# 1992/2001(Rev 4) Model 702 SAR COMPARISON

**APPENDIX A - Detailed Comparison of Drawing Changes  
Between R70290 Rev K and 70290 Rev D**

**Drawing Changes from the 1992 SAR for the 702  
(SAR Revision 4) 6 Jul 01**

A-1 **Model 702 Isotope Shipping Container Descriptive Assembly, R70290, 9 Sheets,  
Revision K**

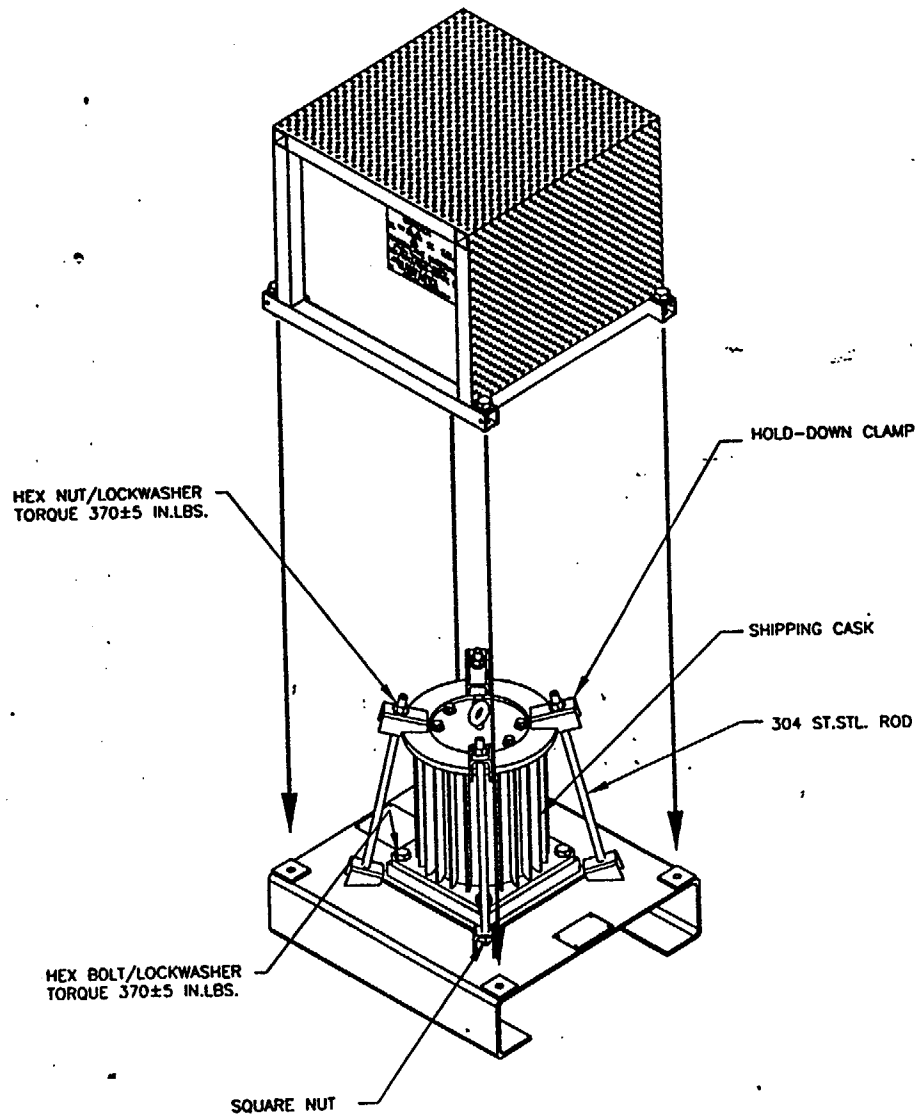
R70290, Sheet 1 of 9

- 1 Torque values for the cover bolts was changed from 517 in lbs to 370 in lbs. This change was made to reflect actual torque values used for these bolts which is based on standard practice guidelines of torquing bolts to 75% of the bolt yield strength. Test plan specimens were torqued to the value listed on these drawings.
- 2 A notation was added to reference welding reference requirements for all sheets in drawing R70290.
- 3 Physical dimensions for the 702 warning label are specified and the material thickness increased from 1/16" to 3/8" steel.
- 4 Steel type (304) for the cage plate specified.
- 5 A generic dimensional tolerance of 1/16" is added as well as specific tolerances for applicable dimensions.
